Process Sheet

Customer : CU-DAR001 Dart Helicopters Services	Drawing Name : BLOWER MOTOR SUPPORT
Job Number : 26610	
Estimate Number : 12311	
P.O. Number : N/A	Part Number : D3471041
This Issue : 4/10/2006 S.O. No. : N/A	Drawing Number : D3471 REV.A
Prsht Rev. : NC	Project Number : N/A
First Issue : N/A Type : SMALL /MED FAB	Drawing Revision : A
Previous Run : 26464	Material : N/A
Written By : <u>See LA comment below</u>	Due Date : 4/28/2006
Checked & Approved By : <u>FF 06.04.10</u>	Qty: 1 Um: Each
Comment : est rev A 06.03.02 New issue EC

DESIGN <i>[Signature]</i>	DRAWN BY <i>[Signature]</i>	DART AEROSPACE LTD HAWKESBURY, ONTARIO, CANADA	
CHECKED <i>[Signature]</i>	APPROVED <i>[Signature]</i>	DRAWING NO. D3471	REV. A SHEET 1 OF 5
DATE 05.12.21		TITLE BLOWER MOTOR SUPPORT	SCALE 1:6
A	05.12.21	NEW ISSUE

DETAIL A: COUNTERSINK HOLES
(RIVET NOT SHOWN FOR CLARITY)
SCALE 1:1

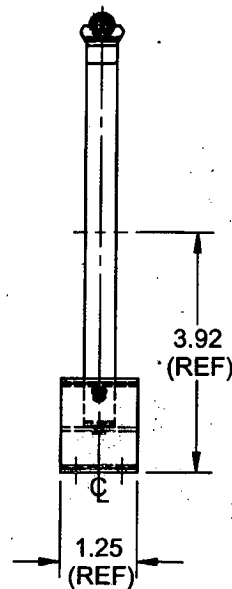
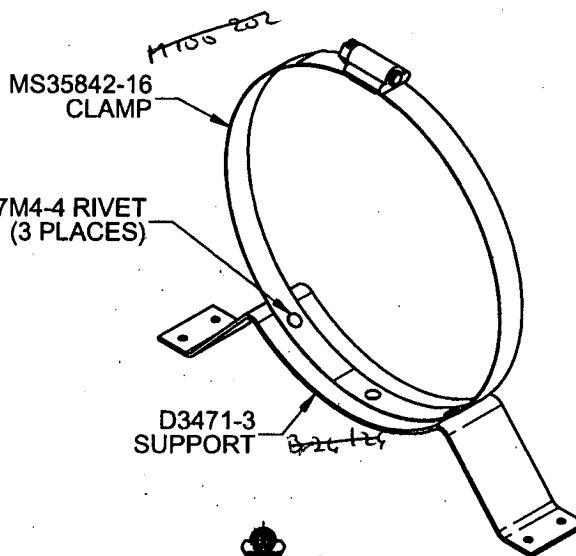
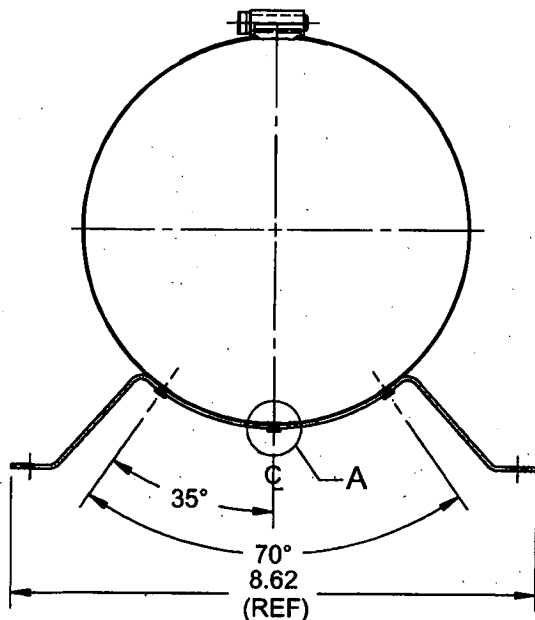
LOCATE AND TRANSFER DRILL
#30 ($\phi 0.129$) THRU HOLE FROM
D3471-3 TO MS35842-16 CLAMP
AND C'SINK $\phi 0.230 \times 100^\circ$
(3 PLACES)
